# Safety Recall Trucks

Date	Group.	No.	Page
02.14	<b>SC0374</b>		1(5)

Automatic Over-Speed Protection  
Shutdown System  
CHU, CXU, GU

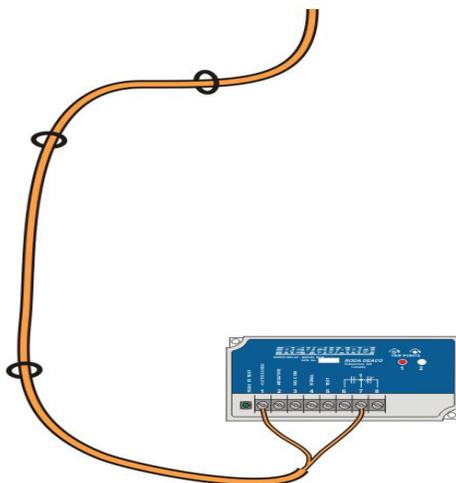
10. Route the wire up to the fuse block (x40) and install onto position 2 (Batt+).

9. Connect the new power wire.  
NOTE: Technician to fabricate new power wire using a #10 ring terminal with heat shrink, terminates to junction block X40 power stud 2 (battery), and other end to terminate at XC1D test switch (pin 4). This 14 ga. wire is to be approx. 975 mm (38 inches) long.

- Strip the remaining end of XC1D, connected to the test switch pin 4, to length 8mm (0.3 in.).
  - Wire(s) XC1D, (connected to test switch pin 4) and new 14 ga wire coming from power junction block X40 power stud 2 (battery) need to be spliced together. This is done by crimping the wires together with a butt splice and then sealing the connection with heat shrink.

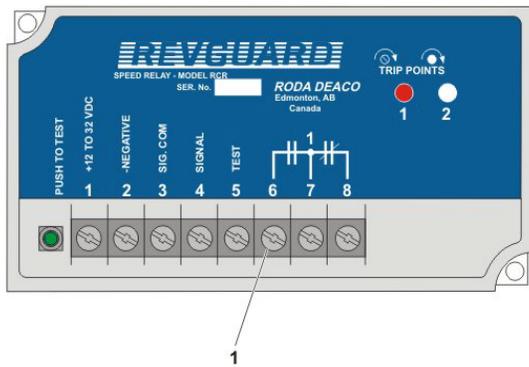
16. Move wire/ring terminal PBSW, labeled “speed switch” from position 7 to position 6 on the Revguard Automatic Over-Speed Protection Shutdown Module.

NOTE: Circuit PBSW should now be located on position 6.

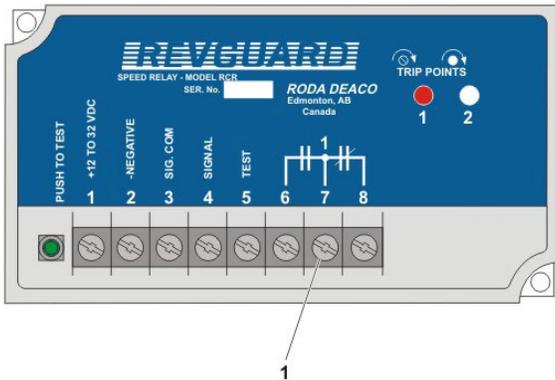
17. Move wire/ring terminal F11D, labeled “speed switch” from position 8 to position 7 on the Revguard Automatic Over-Speed Protection Shutdown Module.

NOTE: Circuit F11D should now be located on position 7.
